Access Compliance Report Public Rights-of-Way (Curb Ramps)

Main Street: MONROE_ST Cross Street: HAZARD_AVE Location: NE

ADA ID: RPRK211004141136 Ramp Type: Type 1 - Perpendicular Diagonal Initial Pass/Fail: Fail Overall Compliance: No Severity Score: 15

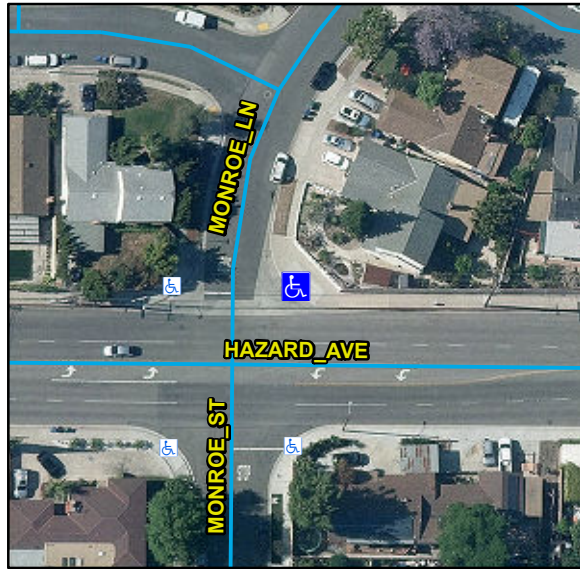
Compliance	Description	Data	Compliance	Description	Data
N/A	Ramp Length (in)	135	N/A	Flare Type LT	
Yes	Ramp Width (in)	48			N/A
No	Ramp Run Slope (%)	10.2	N/A	Flare Slope LT (%)	N/A
Yes	Ramp Cross Slope (%)	1.6	N/A	Flare Traversable LT	N/A
N/A	Landing Present	N/A	N/A	Flare Type RT	
N/A	Landing Length (in)	N/A			N/A
N/A	Landing Width (in)	N/A	N/A	Flare Slope RT (%)	N/A
N/A	Landing Run Slope (%)	N/A	N/A	Flare Traversable RT	N/A
N/A	Landing Cross Slope (%)	N/A	N/A	DWS Provided	N/A
N/A	Landing Movement Obstructed?	N/A	N/A	DWS Contrast	N/A
	Landing Movement Type	N/A	N/A	DWS Length (in)	N/A
N/A	Landing Shared	N/A	N/A	DWS Full Width	N/A
N/A	Clear Space	Yes	N/A	DWS Offset Left (in)	N/A
N/A	Clear Space To Crosswalk (in)	N/A	N/A	DWS Offset Right (in)	N/A
N/A	Marked Crosswalk 1	No	N/A	Marked Crosswalk 2	No
	Crossing 1 Direction	W		Crossing 2 Direction	S
	Marked Crosswalk 1 Width (in)	N/A		Marked Crosswalk 2 Width (in)	N/A

N/A	Ramp Inside Crosswalk 1	N/A	Yes	Ramp Inside Crosswalk 2	N/A
	Crossing 1 Slope (%)	6.6		Crossing 2 Slope (%)	0.9
	Crossing 1 Cross Slope (%)	2.8		Crossing 2 Cross Slope (%)	0.7
N/A	Gutter Ponding	N/A	No	Curb Slope	9.2
Yes	Gutter Lip Height (in)	0		Road Run Slope (%)	1.4
N/A	Gutter Run Slope (%)	N/A		Road Cross Slope (%)	2.1
N/A	Gutter Cross Slope (%)	N/A			
Yes	Overall Surface Condition: Acceptable		Yes	Perp Joint Present	Yes
	Cross Gutter Present?	Yes		Spandrel Present?	Yes
	Replace Cross Gutter?	No		Replace Spandrel?	No

Remove & Replace Curb Ramp With Two New Directional Ramps or Equivalent.
